Project: Kake Bulk Fuel and Rural Power
System Upgrades

Addendum No. Six

A. Modifications to Kake Rural Power Systems Upgrade Schedule B DRAWINGS:

1
E2.01
ELECTRICAL PLAN
SCALE: 1"=30'-0"

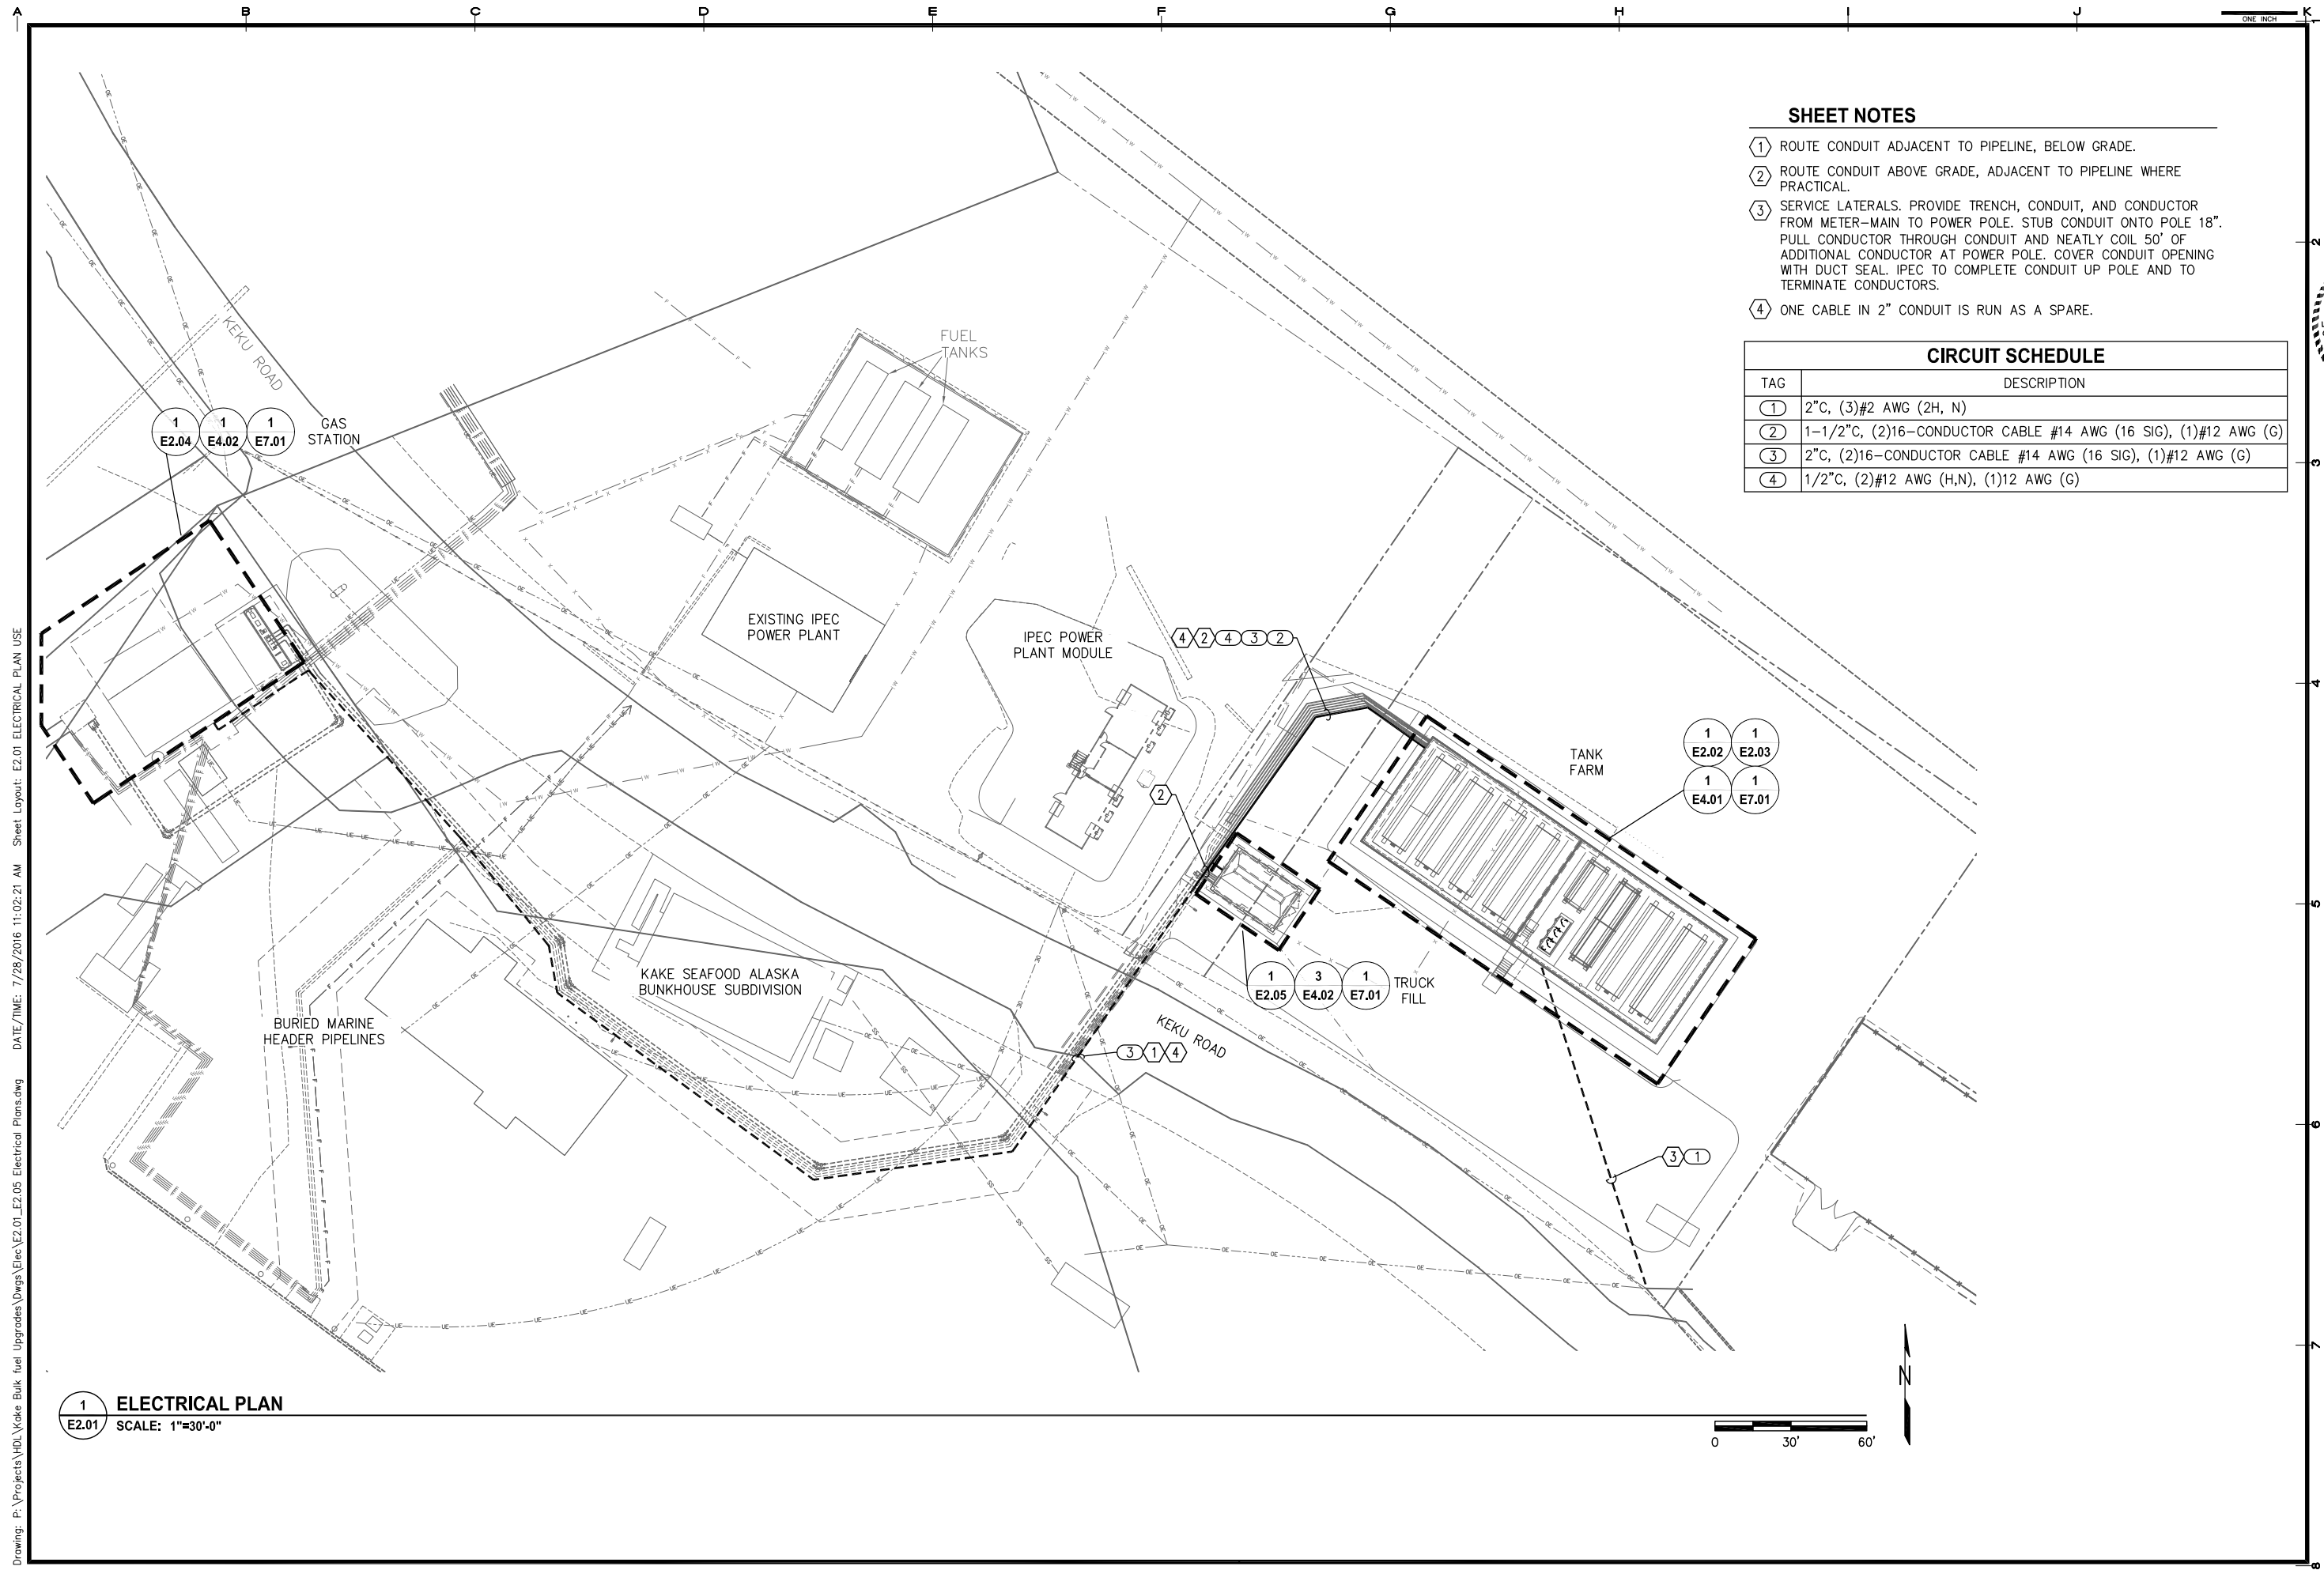
1. Sheet E2.01, General Note 1:

Delete the entire sheet and replace with the attached Sheet E2.01 which includes the following changes:

- *Scale on 2.01 is incorrect, should be 1"=30'.*
- *(1ea) 2" crossing from CP-A to CP-B. Tag #1 on E5.01 is incorrect and should read "See sheet E2.01 for details".*
